UNITED STATES PATENT AND TRADEMARK OFFICE

APPLICATION NO.	FILING DATE	FIRST NAMED INVENTOR	ATTORNEY DOCKET NO.	CONFIRMATION NO.
10/782,574	02/18/2004	Ho Lu	JCLA12196	4739
23900	7590	08/18/2005	EXAMINER	
J C PATENTS, INC. 4 VENTURE, SUITE 250 IRVINE, CA 92618			KOVAL, MELISSA J	
			ART UNIT	PAPER NUMBER
			2851

Office Action Summary

DETAILED ACTION

FIG. 4 (PRIOR ART)

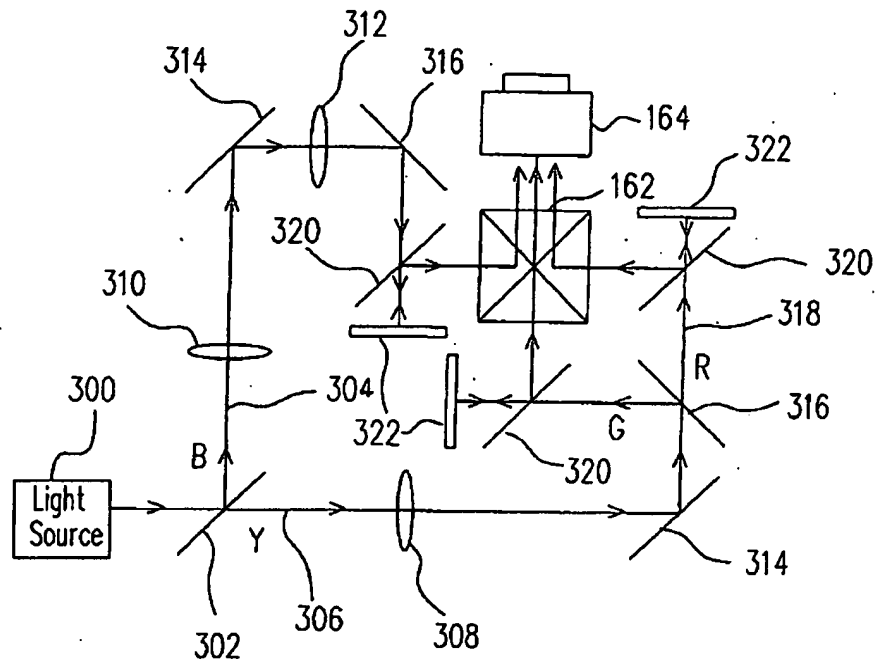
The drawings were received on July 20, 2005. These drawings are approved. Note with respect to page 2 of Applicant's remarks filed on July 20, 2005, the section titled "In the Drawings", Applicant refers to Figures 4, 7, 9, 10 and 11, only, therein. However the actual replacement Sheets of Drawings also include changes to Figure 12.

Please amend Figures 4, 7, 9, 10 and 11 as shown in red ink in the separate accompanying pages. Proposed corrected drawing including corrected Figures 4, 7, 9, 10 and 11 is also attached hereto in separate accompanying pages. Reconsideration is respectfully requested.

*Drawing
Corrections
approved
for entry
MSK
8/15/05*
